THE COUNTY OF CHESTER

Chester County Planning Commission

Government Services Center, Room 270
February 13, 2019

AGENDA

Site Plan Detail, Sheet 1: Preliminary Subdivision - Troutbeck Farms

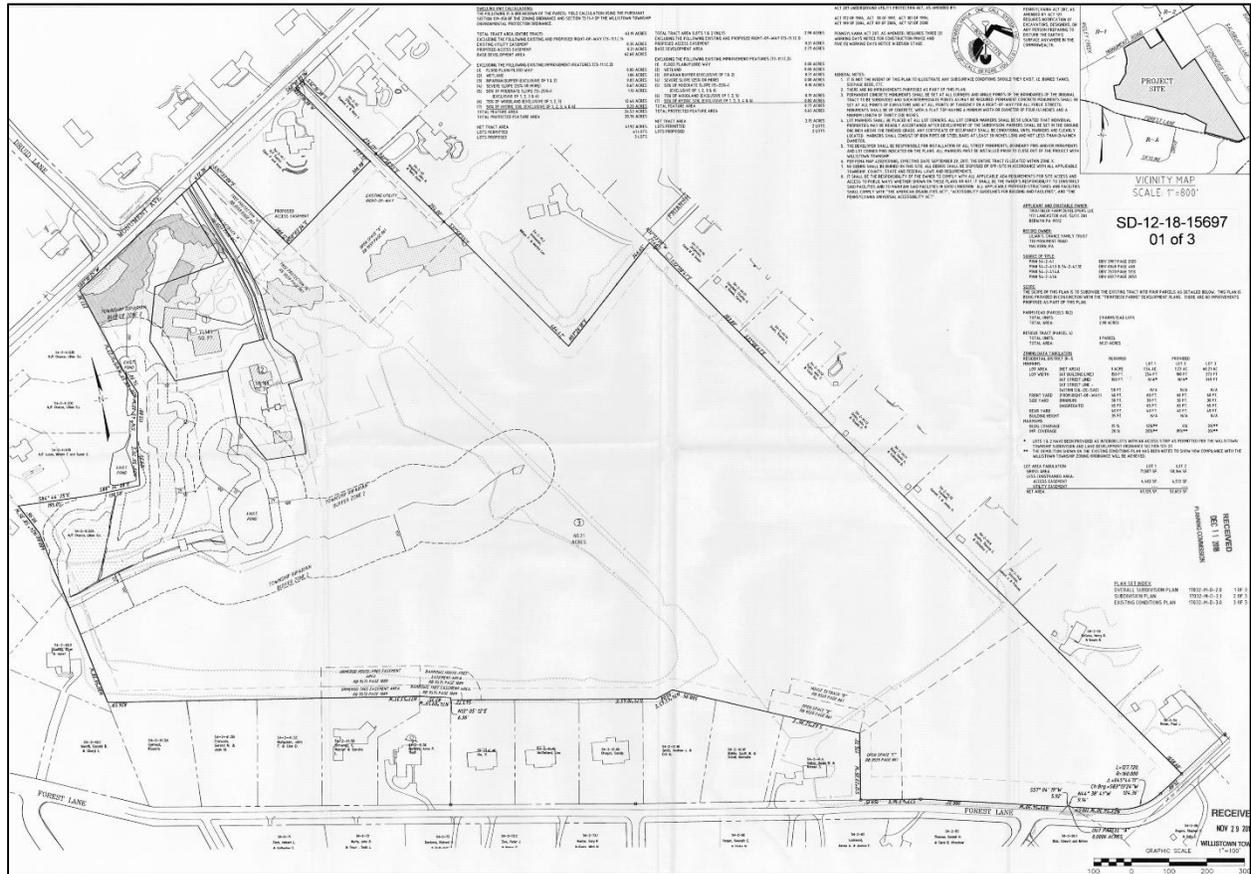
- The “Existing Paving to be Removed” designation on Sheet 3 appears to indicate that existing buildings and paving will be removed as part of this plan submission. This should be clarified by the applicant. As noted in our previous review (CCPC# SD-06-18-15453), the 2011 Township Historic Resource Atlas identifies that the project site contains three Class II historic resources. The applicant should identify the location of the existing historic resources on the site plan, and specify the level of preservation and intended use of these historic resources. The Township should reserve granting final plan approval until this proposal has been reviewed by the Township’s Historical Commission. “Appreciate” Objective A of *Landscapes3*, the 2018 County Comprehensive Plan, is to preserve historic resources in their context while supporting appropriate reuse as a vital part of our community infrastructure and character.

6. Vehicular access to Lots 1 and 2 will be provided from a shared access easement, and the site plan also depicts the location of several easement areas on Lot 3. The details of these easements should be incorporated into the deeds of the appropriate lots.
7. The Legend on Sheet 3 does not include an area symbol for existing buildings that will remain. This should be corrected by the applicant.
8. A minimum of four (4) copies of the plan should be presented at the Chester County Planning Commission for endorsement to permit recording of the final plan in accord with the procedures of Act 247, the Pennsylvania Municipalities Planning Code, and to meet the requirements of the Recorder of Deeds and the Assessment Office.
